From: Simon Davis
Sent: 23 April 2019 11:10
To: Planning Scanning
Subject: FW: FP/64/19/PL Mow Cottage
Attachments: Map .pdf

MOW COTTAGE, WORMS LANE, FELPHAM

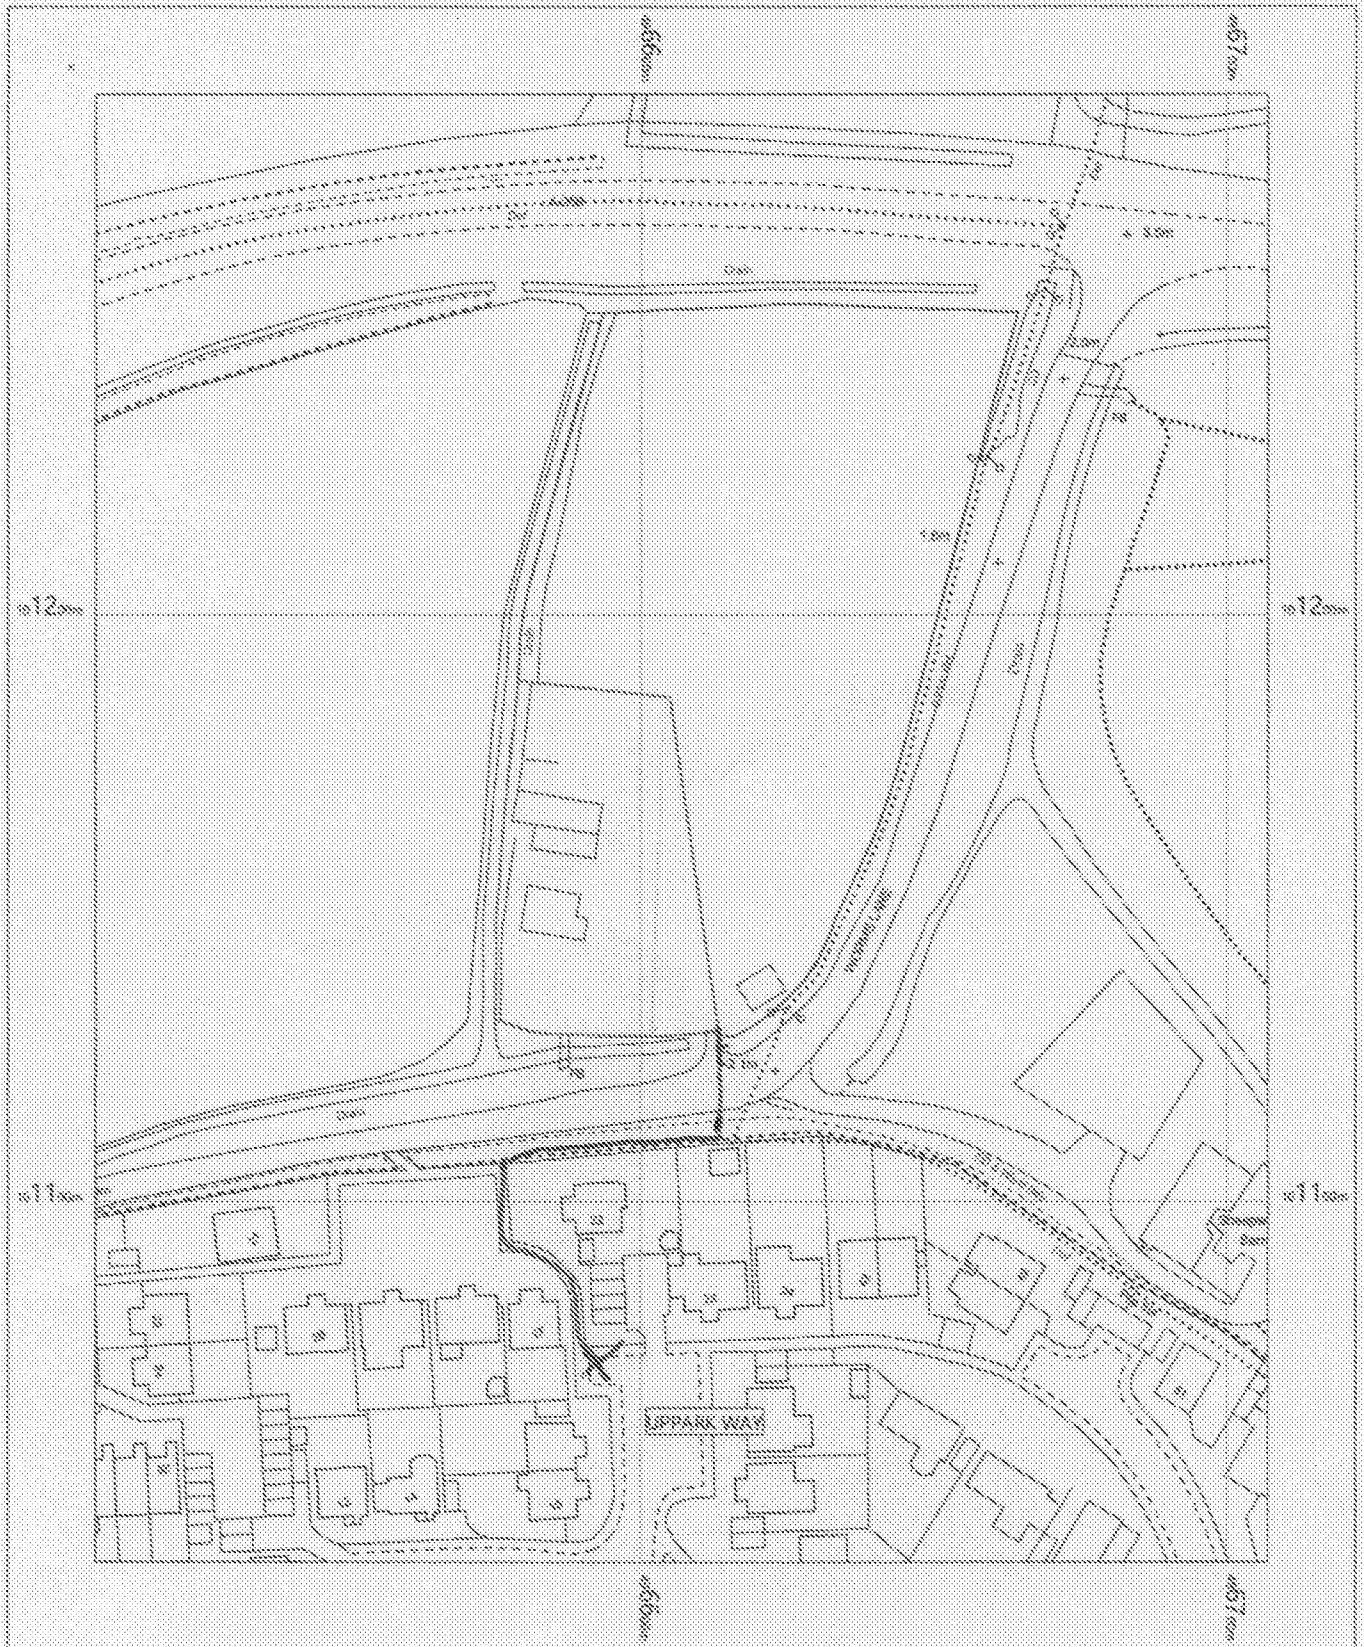
With regard to the refuse collection the preferred option for the applicants would be as I set out in my Design & Access Statement that they wheel the bins to the collection point in Uppark Way. As shown on the attached OS plan this is a nearer and easier route to wheel the bins than taking them up to the A259 junction. There is also a dog waste bin at the Uppark Way location. I would have thought it would be more convenient for the refuse collectors as they wouldn't have to make a separate stop on the A259.

With regard to the council's ecologist's requirement for a 5 metre buffer zone around the construction site for dormice etc. these can easily be achieved off the southern, eastern and northern boundaries. It is however tight on the western boundary where there is just about 5 metres between the proposed side of the new building and the boundary, so I would suggest that we move the building over say 1.5-2 metres to the east so that the buffer zone can easily be achieved. If this acceptable I will get a revised site plan done.

“The plans do not show any refuse and recycling collection arrangements, although Manual for Streets does state that residents should not have to travel over 30m to put bins out and collection vehicles should not have to travel in excess of 25m to collect/deposit bins. This is however a matter of amenity for the Local Planning Authority (LPA) to consider. The applicant is advised to contact the waste disposal authorities to ascertain whether the practise would be acceptable.”

I have today spoken with our Cleansing Operations Manager and he has said that a Council refuse vehicle would not be able to go down Worms Lane to pick up bins and that collection should instead be from the junctions of Worms Lane and the A259 (where a refuse vehicle could pull in briefly).
